Access Compliance Report Public Rights-of-Way (Curb Ramps)

Main Street: PARK_SOUTH_DR Intersection ID: 21044 Cross Street: ROUND OAK RD Location: SE **Overall Compliance: No** ADA ID: B1F58B4566C6 Ramp Type: Directional1 Initial Pass/Fail: Fail Severity Score: 21.25

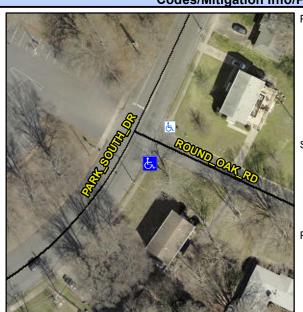
ROUND OAK RD Street 1 Name Stop Condition-Street 1 StopSign N/A Street 2 Name Stop Condition-Street 2 N/A Possible Solutions: Remove & Replace Entire Ramp. Surveyor Notes: N/A PROW/ADA: R304.5.1, R304.2.2

Compliance Description Data Compliance Description Data N/A N/A Ramp Length (in) 134.0 Grade Break? N/A 40.0 N/A No Ramp Width (in) Grade Break Slope (%) 0.0 N/A No Ramp Slope (%) 10.2 Grade Break XSlope (%) 0.0 Ramp XSlope (%) 1.9 Yes N/A Flare Type LT N/A N/A Flare Type RT N/A N/A Flare Slope LT (%) N/A N/A Flare Slope RT (%) 0.0 N/A Flare Traversable LT? N/A N/A Flare Traversable RT? N/A N/A 0.0 N/A **DWS Provided?** Landing Length (in) N/A N/A Landing Width (in) 0.0 N/A **DWS Contrast?** N/A N/A Landing Slope (%) 0.0 N/A DWS Length (in) N/A N/A N/A Landing X Slope (%) 0.0 DWS Full Width? N/A N/A Landing Curb? (Y/N) N/A N/A DWS Offset LT (in) N/A N/A Shared Landing? N/A N/A DWS Offset RT (in) N/A N/A **Gutter Ponding?** 0.0 N/A Gutter Slope (%) N/A N/A Gutter Lip Ht (in) 0.0 N/A Gutter X Slope (%) N/A N/A Painted X Walk1? No Road Slope (%) 0.1 X Walk 1 Direction To N Road X Slope (%) 3.7 X Walk 1 Width (in) N/A Clear Space? N/A 0.1 N/A N/A X Walk 1 Slope (%) Clear Space to XWalk (in) X Walk 1 X Slope (%) 3.7 N/A Storm Grate/Utility Hazard? N/A N/A Ramp inside XWalk1? N/A Storm Grate/Utility Type N/A N/A Any Obstructions? N/A **Obstruction Type** Surface Condition? (G/P) Yes Good N/A N/A Curb Slope (%) 9.3
